# CITY OF ALBUQUERQUE

Hydrology Section Planning Department  
David S. Campbell, Director

**RE: BEK Distribution Facility – 601 Gallatin Pl. NW  
G&D Plan and Drainage Report Engineers Stamp Date: 5/16/2019,  
Hydrology File: FJ10D002G1**

GRADING AND  
DRAINAGE PLAN

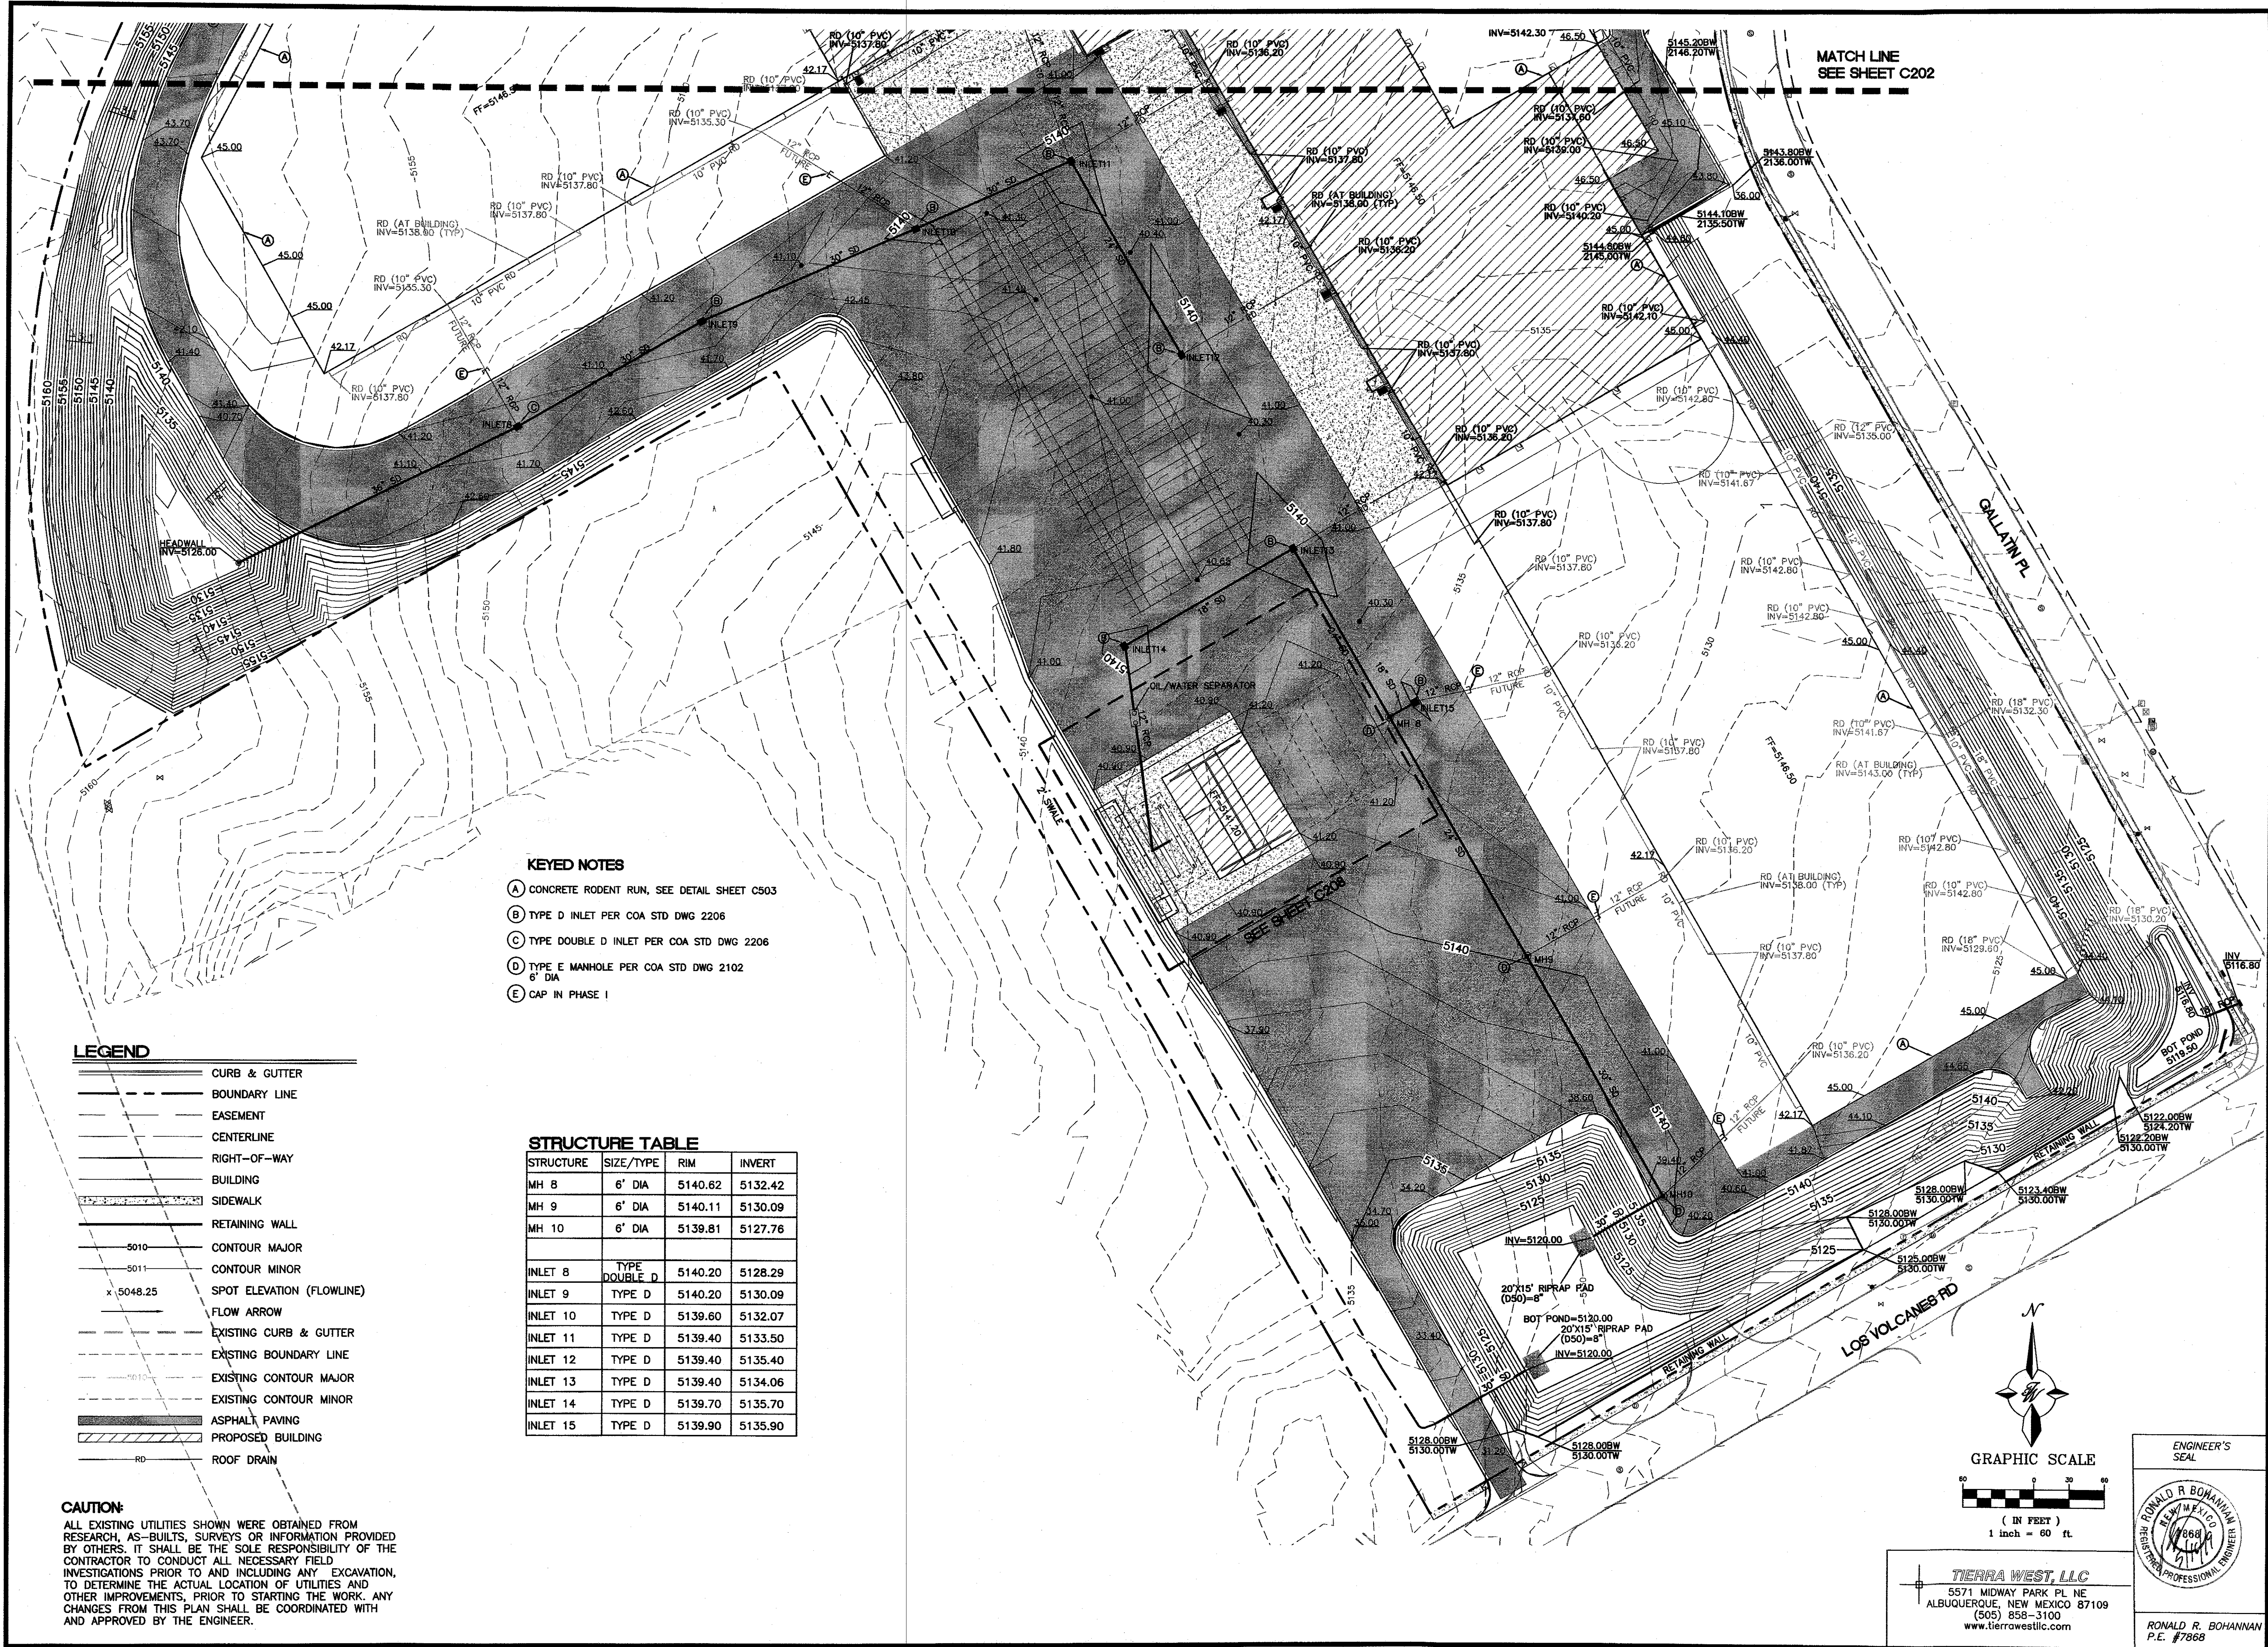
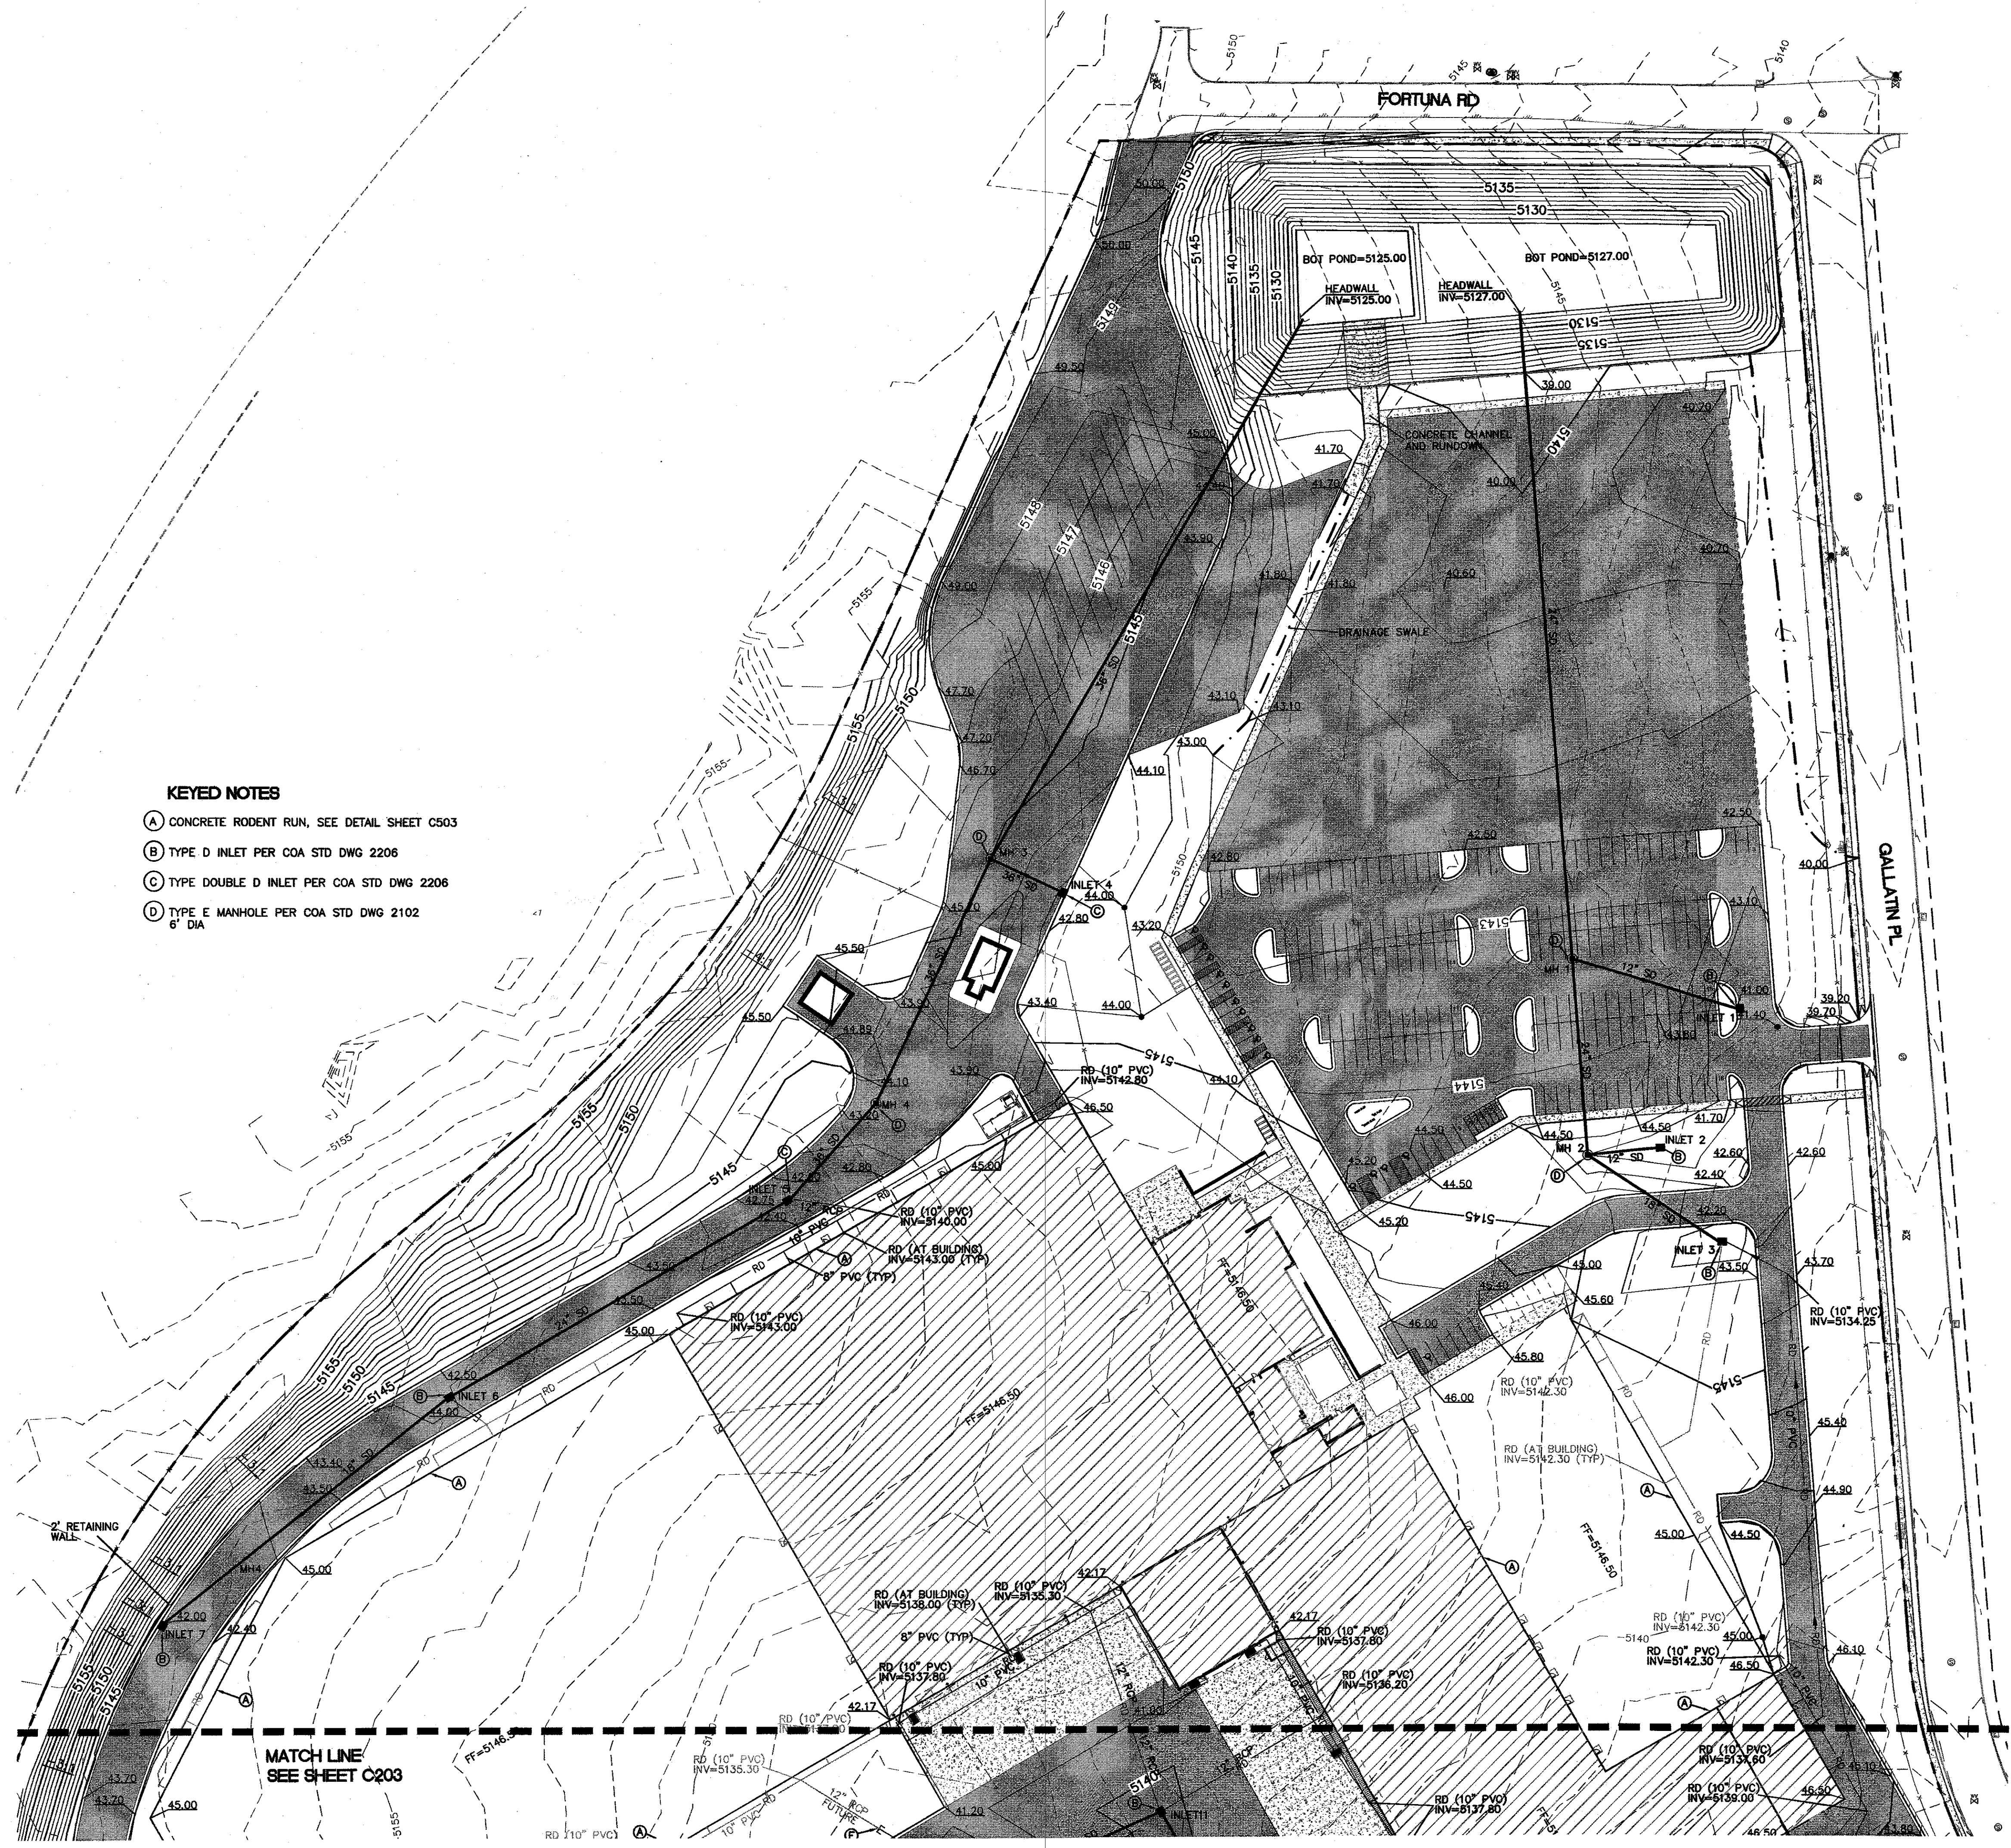
1. The contours on the steep slopes along the west side indicate a 2.6:1 slope. Please either change the slope label from 3:1 to 2.6:1 or change the contours.

2. Please add a note near the west slope that states "All disturbed areas must be stabilized prior to Engineer's Certification for Certificate of Occupancy".

6. How will drainage get out of the sump in the C&G on the east side of the Staging area?

8. Please label the contours in the north east corner of the parking lot and verify that the spot elevations agree with the contours. If they are not 5141 and 5142 then please revise the grading to decisively contain the parking lot drainage and convey it into the north pond.

9. The contours indicate excessively steep slopes west of the staging/parking lot about 350' south of the northwest corner of the site. The contours indicate erratic slopes varying from 1% to 10% with abrupt grade changes in the northwesterly 250' of the staging/parking lot. Please revise the grading.

10. The Contours between 5140 and 5150 indicate a slope of about 2:1 on top of the sidewalk in the public right of way at the west end of Fortuna. Please revise the grading and add a typical section to the G&D Plan showing the sidewalk, ROW line and slope. If a retaining wall is added, show the footer with dimensions from the footer to the ROW line. Also show the fence on the G&D Plan and in the section with dimensions.

12. Please add the fence to the legend. Please also identify the bold line style - line, dot, line, dot - shown in the buffer between the street and parking lot in the north east corner of the site.

13. Please show the PNM easement adjacent to and on this tract in the west corner. Either revise the plan to eliminate the grading within the easement or provide written permission from PNM for grading inside of their easement.

14. The finished contours are missing between the east side of the parking lot and the street in Gallatin Place and Los Volcanes Road. Please show proposed contours all of the way to the existing street to indicate the proposed grade of the sidewalk in the public right of way and the landscape area on the private side of the sidewalk. Also please add a few typical sections showing the existing C&G the new sidewalk, the ROW line, the fence, and the slope and/or retaining wall with dimensions both horizontal and vertical. Please include the area between the parking lot and the Right of way in the sections. The area appears to be wide enough to add retention ponds which may be required to limit the discharge to the allowable rates.

24. Please revise the grading of the south pond so a floodwall is not expected to hold back drainage.
25. Please show the existing storm drains in Los Volcanes both private and public. Show and label the private drainage easement from Coke's pond west of this site where it crosses through this site.
